Access Compliance Report
Public Rights-of-Way
(Curb Ramps)

Intersection ID: 46496 **Main Street:** BERE_ISLAND_DR **Cross Street:** TRAILWATER RD **Location:** S

ADA ID: 9F0FD5BE5E4F **Ramp Type:** PerpDiag **Initial Pass/Fail:** Fail **Overall Compliance:** No **Severity Score:** 21.25

Codes/Mitigation Info/Possible Solution

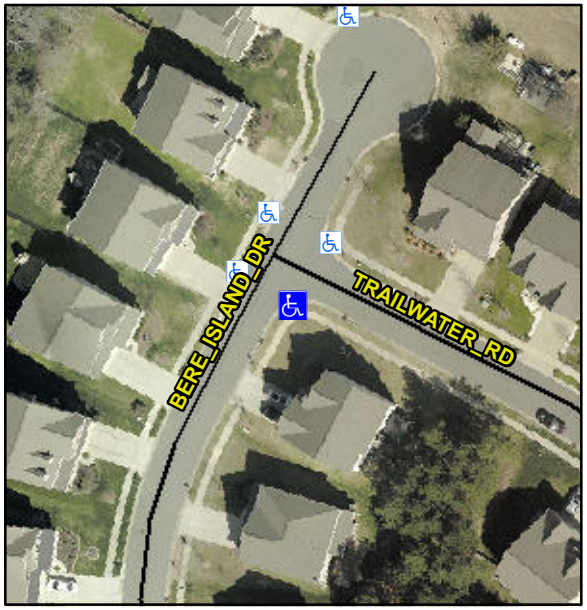
Not Found, R304.5.1, R304.2.2

Compliance	Description	Data	Compliance	Description	Data
N/A	Ramp Length (in)	47.0	No	Ramp Slope (%)	9.3
No	Ramp Width (in)	46.0	Yes	Ramp XSlope (%)	0.0
N/A	Flare Type LT	N/A	N/A	Flare Type RT	N/A
N/A	Flare Slope LT (%)	N/A	N/A	Flare Slope RT (%)	N/A
N/A	Flare Traversable LT?	N/A	N/A	Flare Traversable RT?	N/A
N/A	Landing Length (in)	N/A	N/A	DWS Provided?	N/A
N/A	Landing Width (in)	N/A	N/A	DWS Contrast?	N/A
N/A	Landing Slope (%)	N/A	N/A	DWS Length (in)	N/A
N/A	Landing X Slope (%)	N/A	N/A	DWS Full Width?	N/A
N/A	Landing Curb? (Y/N)	N/A	N/A	DWS Offset (in)	N/A
N/A	Shared Landing?	N/A			
N/A	Gutter Ponding?	N/A	N/A	Gutter Slope (%)	N/A
N/A	Gutter Lip Ht (in)	N/A	N/A	Gutter X Slope (%)	N/A
N/A	Painted X Walk1?	No	N/A	Painted X Walk2?	No
	X Walk 1 Direction	To NE		X Walk 2 Direction	To NW
N/A	X Walk 1 Width (in)	N/A	N/A	X Walk 2 Width (in)	N/A
	X Walk 1 Slope (%)	1.2		X Walk 2 Slope (%)	1.2
	X Walk 1 X Slope (%)	2.2		X Walk 2 X Slope (%)	2.2

Remove & Replace Curb Ramp With Two New Directional Ramps or Equivalent.
